SERIAL: BSEP 02-0124
TSC-2002-06

SUBJECT: Brunswick Steam Electric Plant, Unit Nos. 1 and 2
Docket Nos. 50-325 and 50-324/License Nos. DPR-71 and DPR-62
Request For License Amendments
Technical Specification 3.1.7, "Standby Liquid Control System"
Sodium Pentaborate Solution Requirements

Marked-up Technical Specification Pages - Unit 1

Figure 3.1.7-1 (page 1 of 1)
Sodium Pentaborate Solution Volume Versus Concentration Requirements

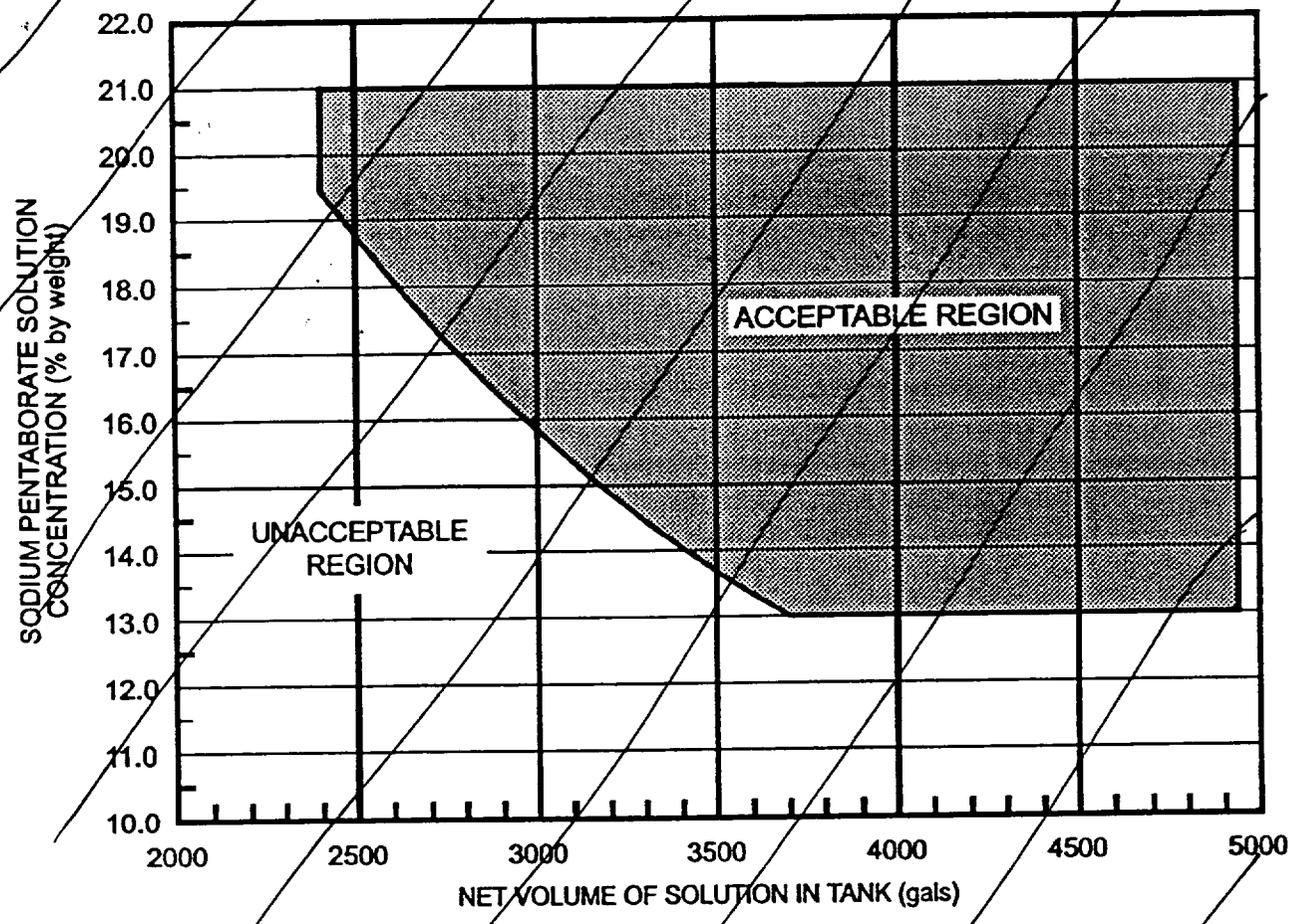
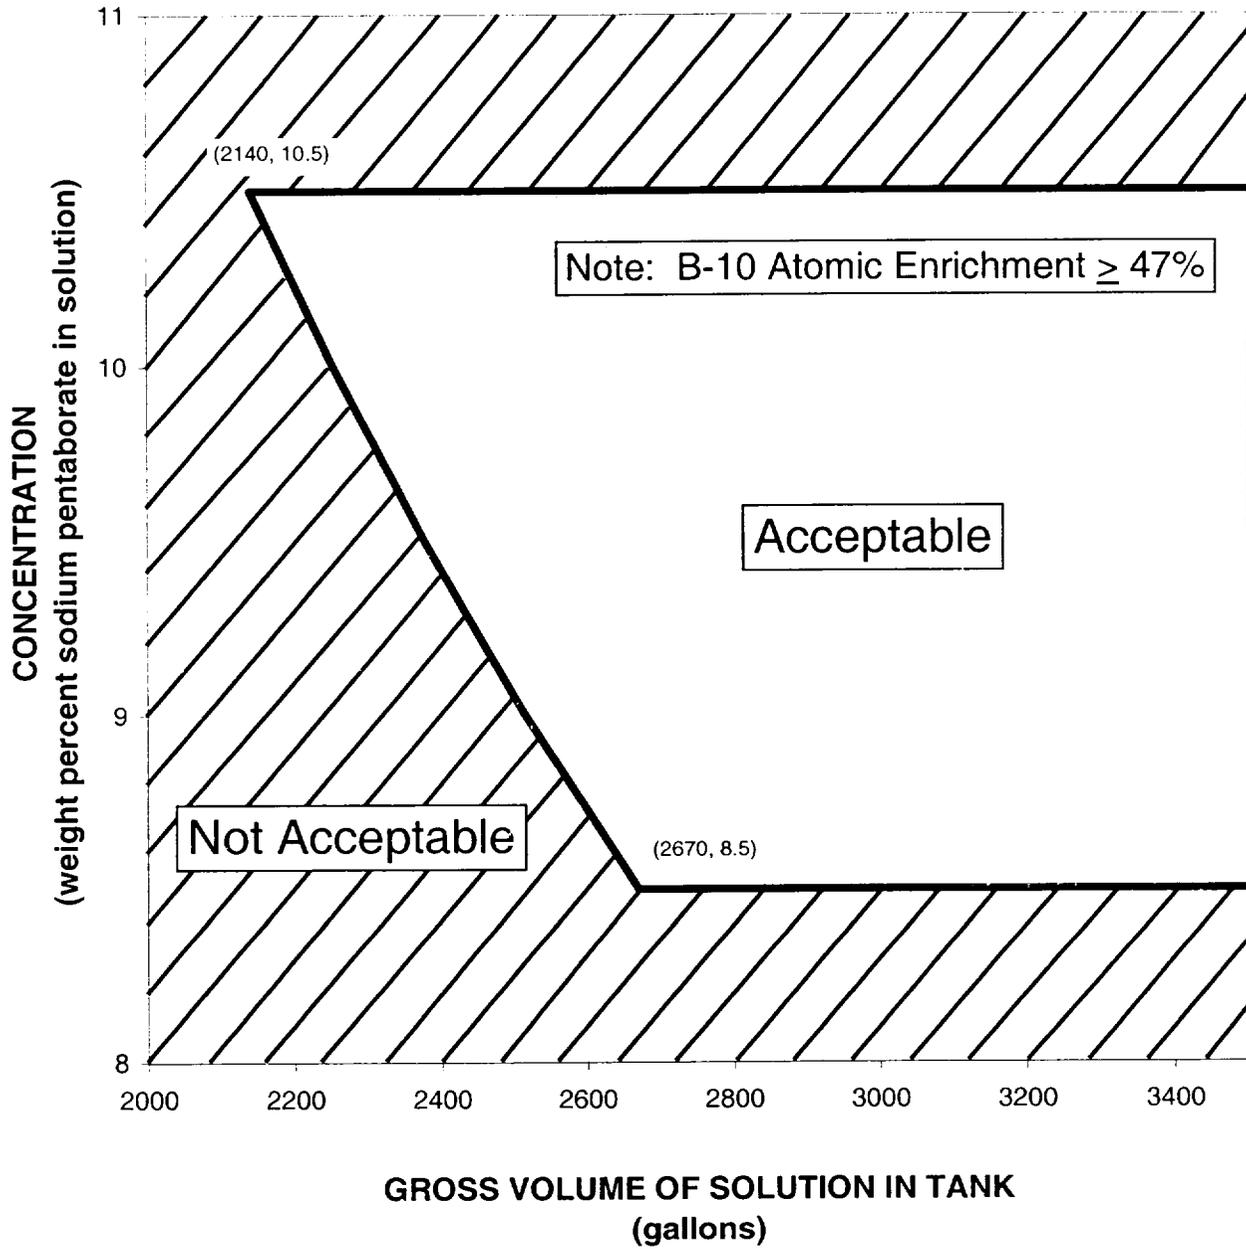
In addition, use of sodium pentaborate solution enriched with the Boron-10 isotope allows the Figure 3.1.7-1, "Sodium Pentaborate Solution Volume Versus Concentration Requirements," minimum sodium pentaborate concentration to be lowered to 8.5 weight percent. This, in turn,

This demonstrates that the equivalency requirement of 10 CFR 50.62 is met. The SLC system volume versus concentration requirements of TS Figure 3.1.7-1 are revised based on the BSEP minimum sodium pentaborate concentration of 8.5 weight percent assumed above. This, in turn, lowers the solution's saturation temperature. Accordingly, the temperature versus concentration requirements of TS Figure 3.1.7-2 are revised. The 5°F margin to the saturation temperature, currently specified in the TS Bases, is maintained in the revised TS Figure 3.1.7-2. Data for solution saturation temperatures below 9 weight percent is not readily available. For this reason, the requirement between 8.5 weight percent and 9.0 weight percent was conservatively maintained at the value for 9.0 weight percent.

Replace with Figure 3.1.7-1
on following page.

Use of sodium pentaborate enriched to 47 atom percent Boron-10 allows the volume versus concentration requirements of TS Figure 3.1.7-1 to be lowered. This, in turn, lowers the solution's saturation temperature. Accordingly, the temperature versus concentration requirements of TS Figure 3.1.7-2 are revised. The existing 5°F margin to the saturation temperature specified in the bases is maintained in the revised TS Figure 3.1.7-2.

Figure 3.1.7-2 (page 1 of 1)
Sodium Pentaborate Solution Temperature Versus Concentration Requirements

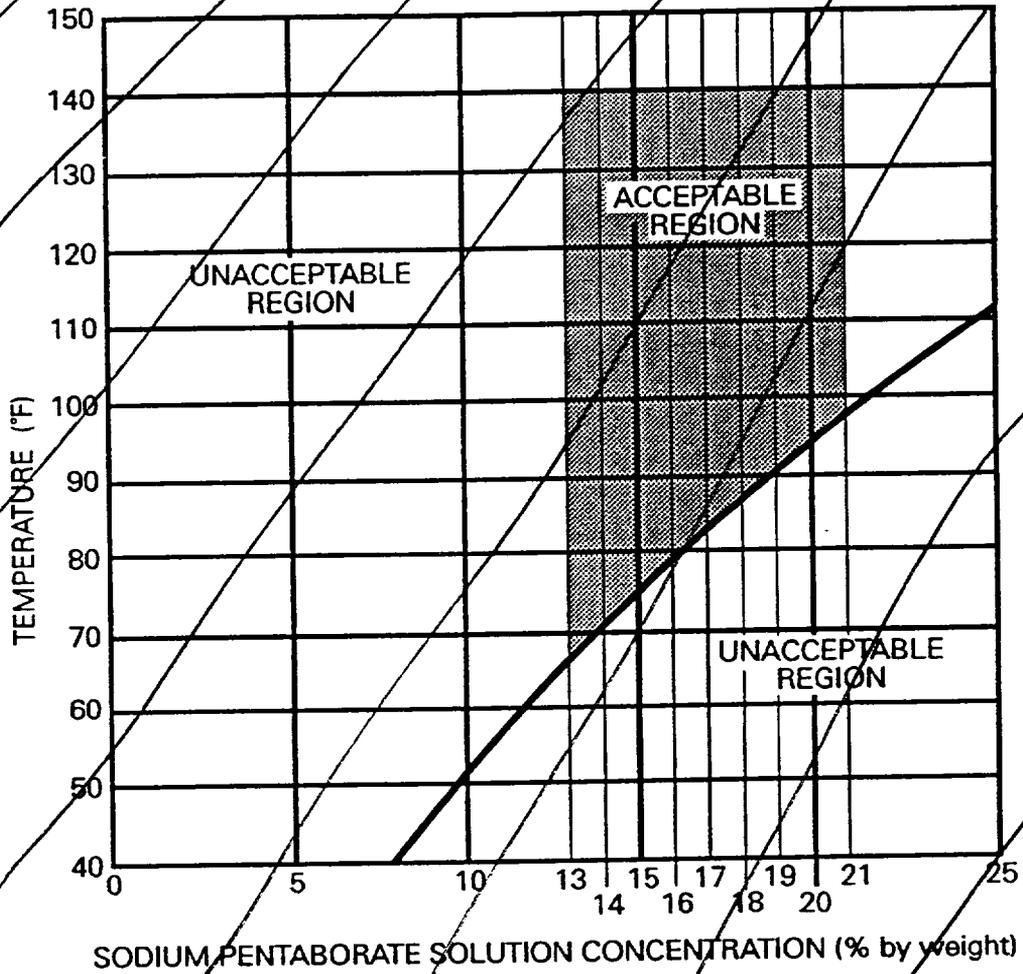
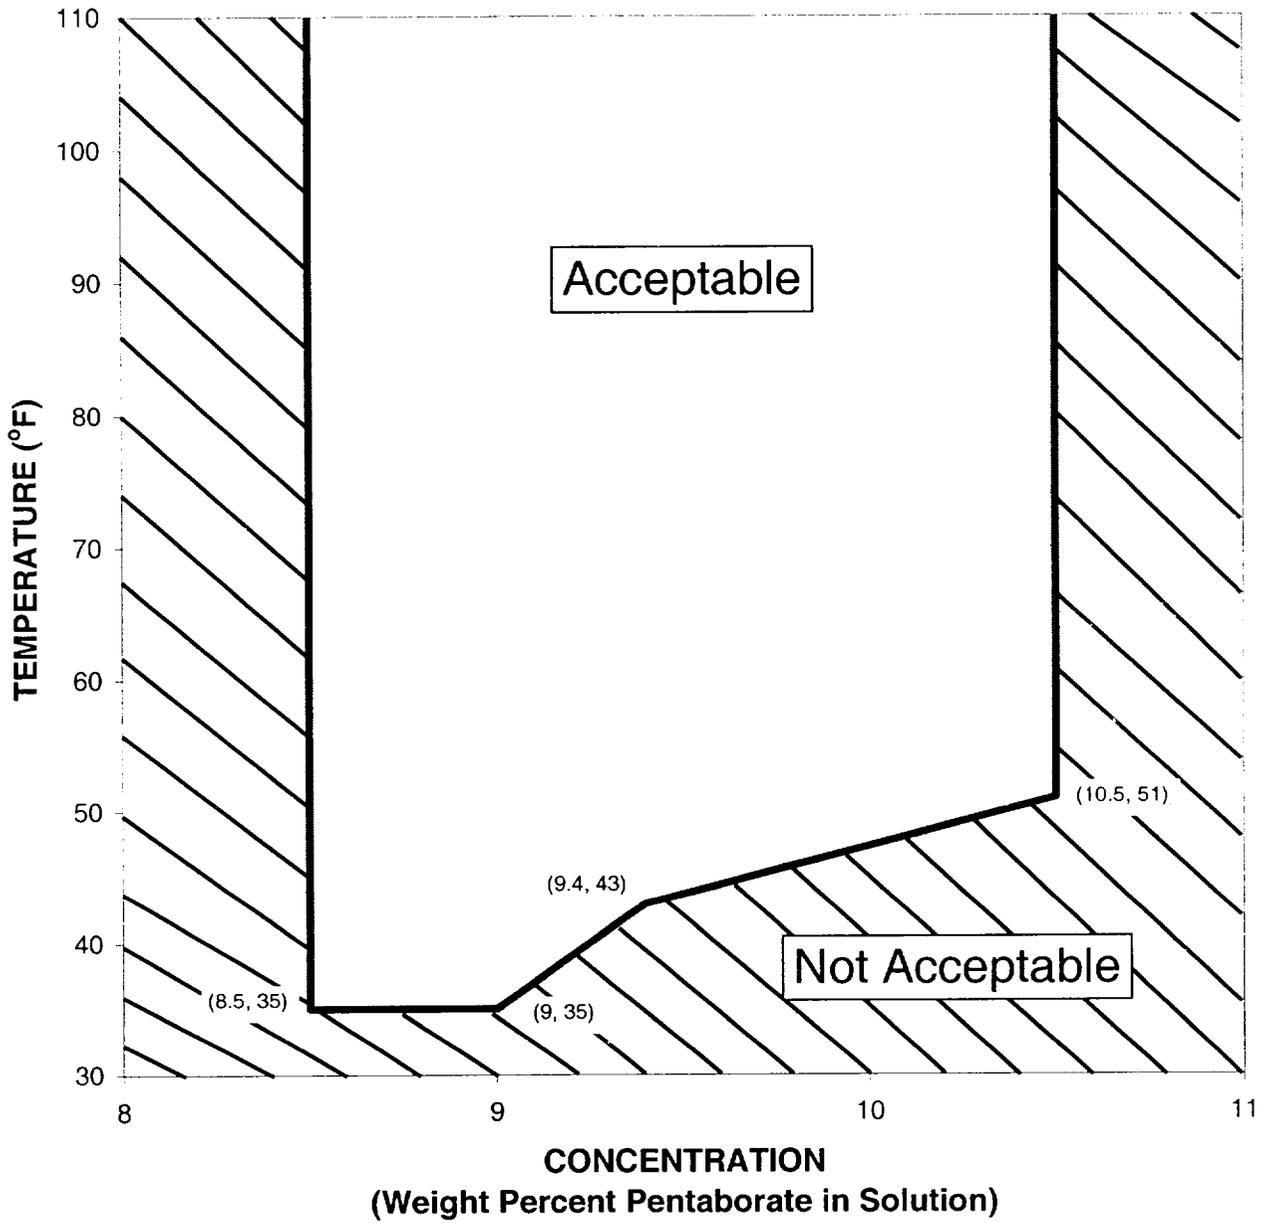
lowers the solution's saturation temperature. Accordingly, the temperature versus concentration requirements of Figure 3.1.7-2, "Sodium Pentaborate Solution Temperature Versus Concentration Requirements," are revised.

Replace with Figure 3.1.7-2
on following page.

Figure 3.1.7-1 (page 1 of 1)
Sodium Pentaborate Solution Volume Versus Concentration Requirements

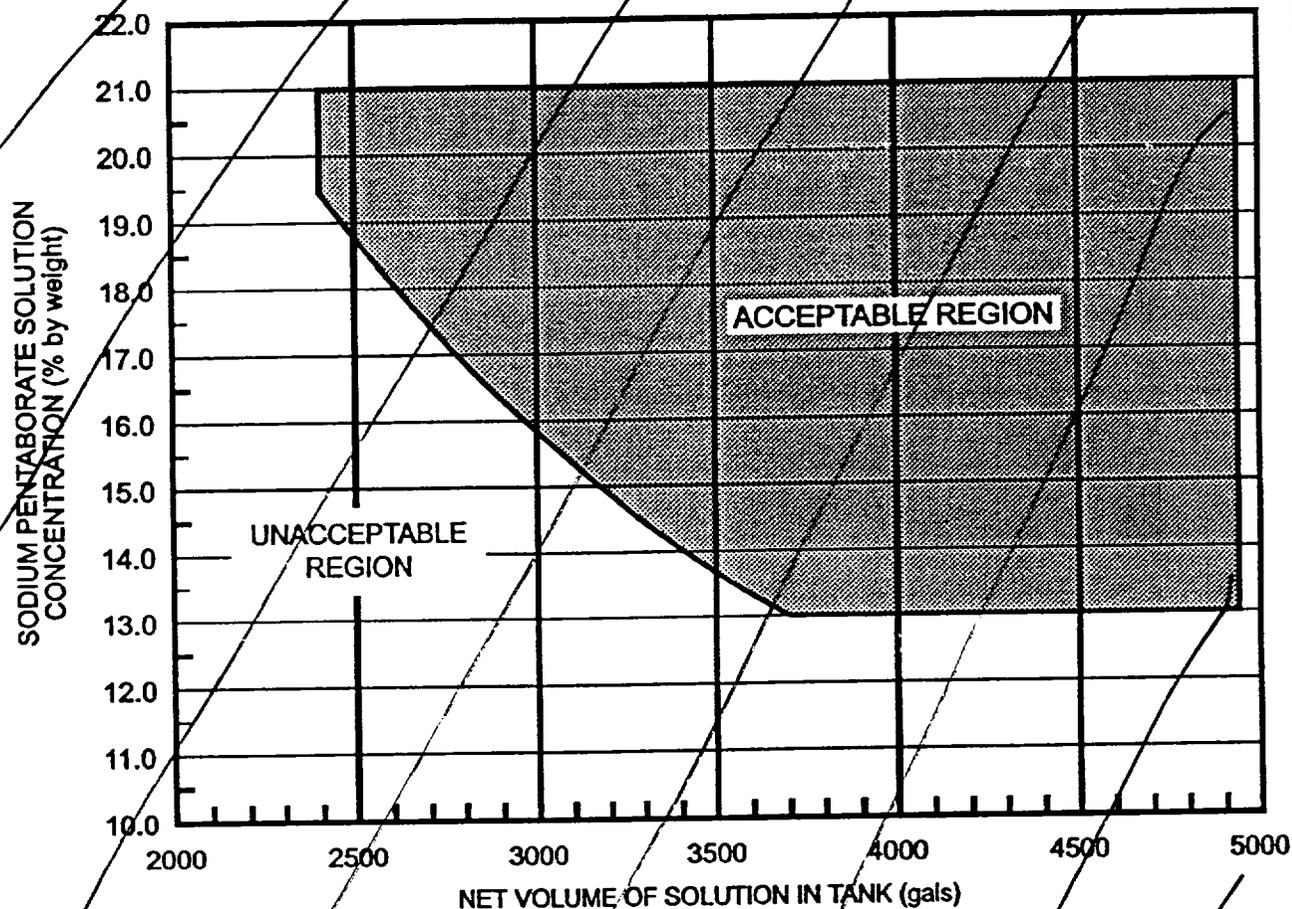
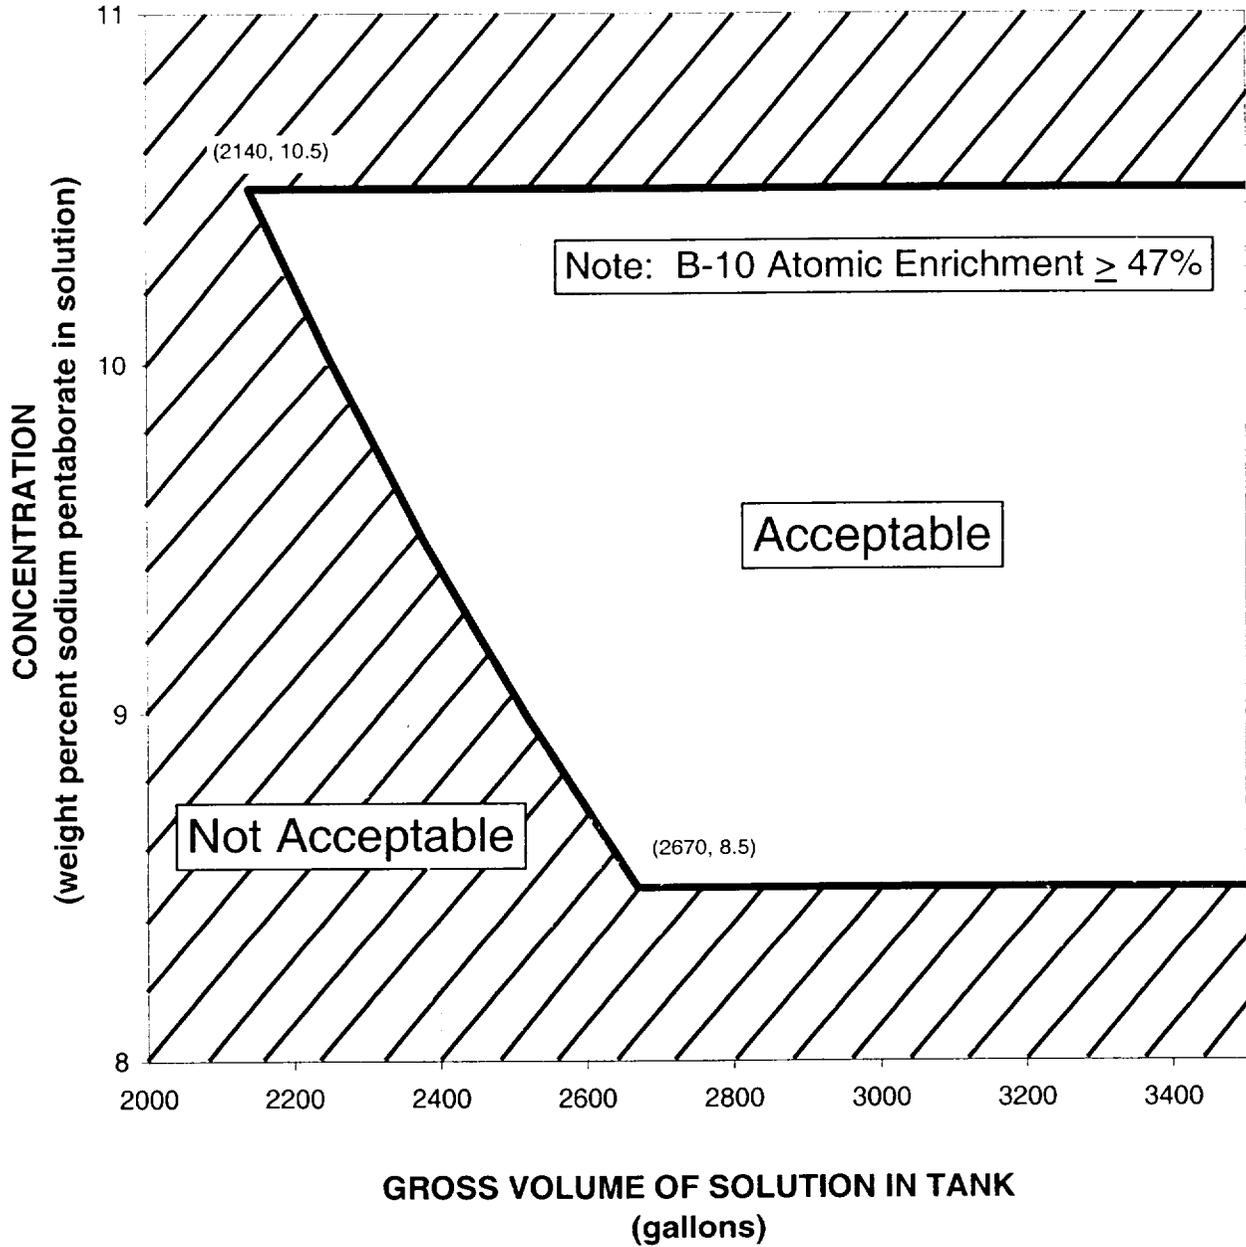
Replace with Figure 3.1.7-1
on following page

Figure 3.1.7-2 (page 1 of 1)
Sodium Pentaborate Solution Temperature Versus Concentration Requirements

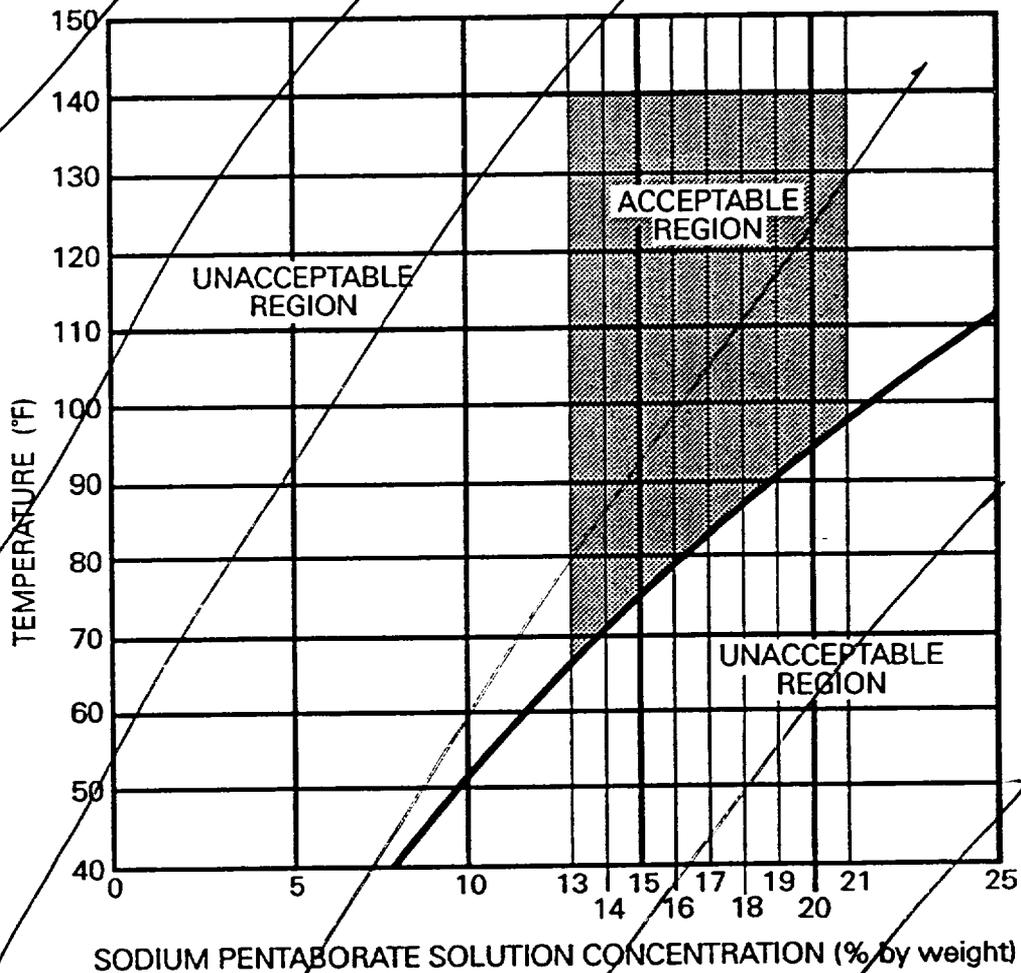
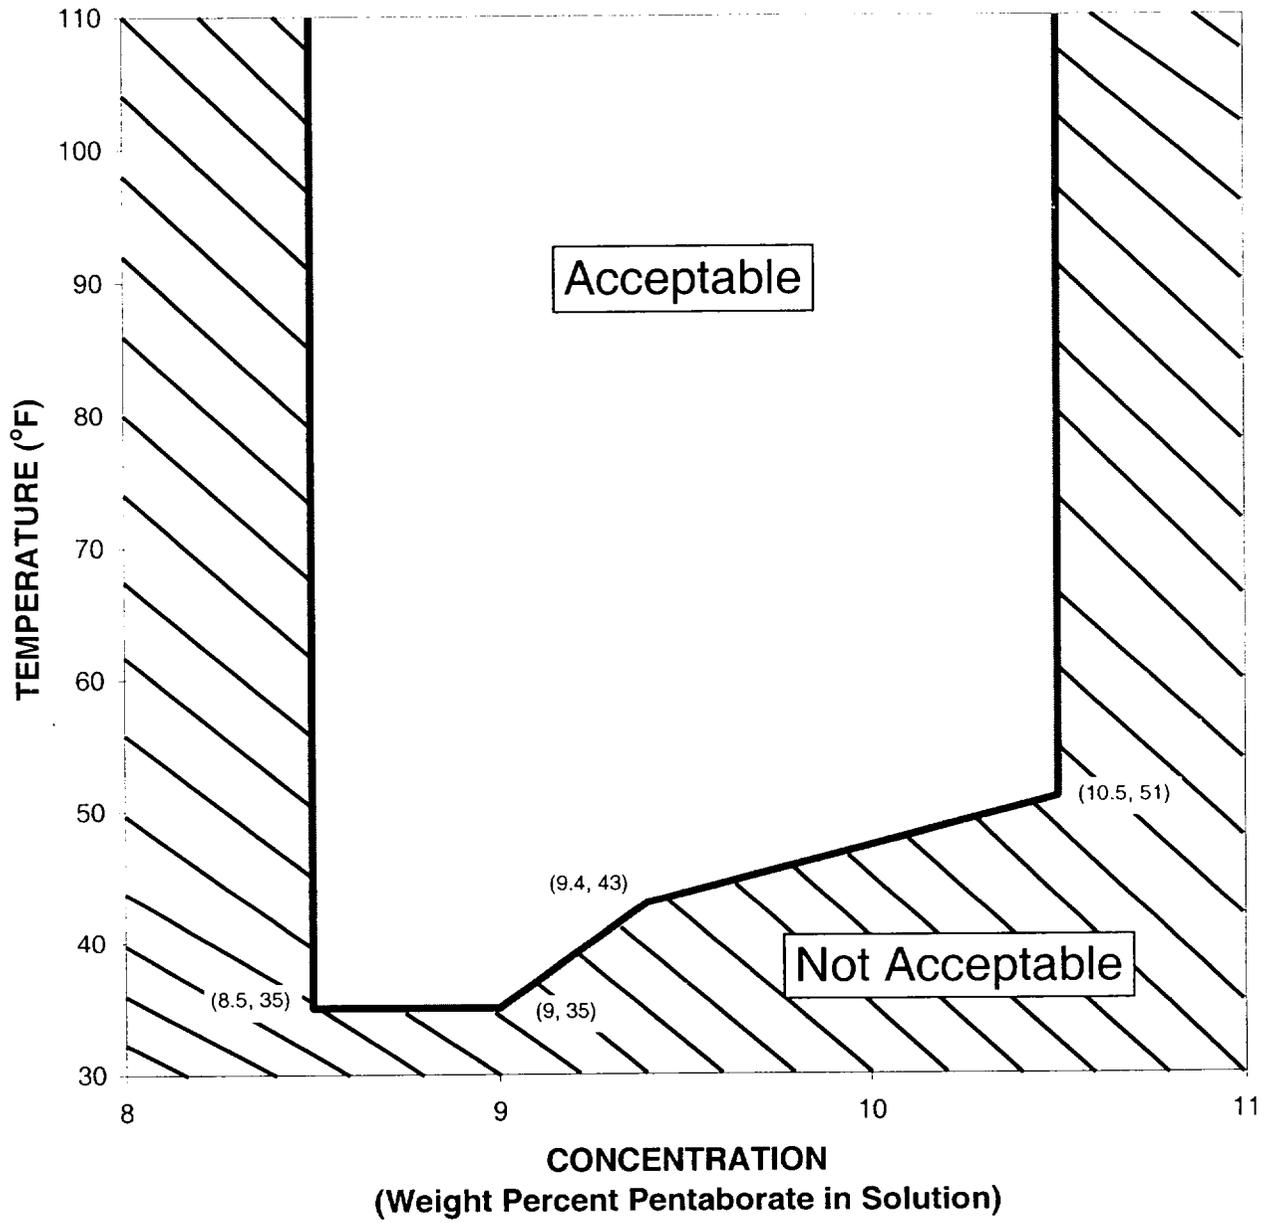
Replace with Figure 3.1.7-2
on following page
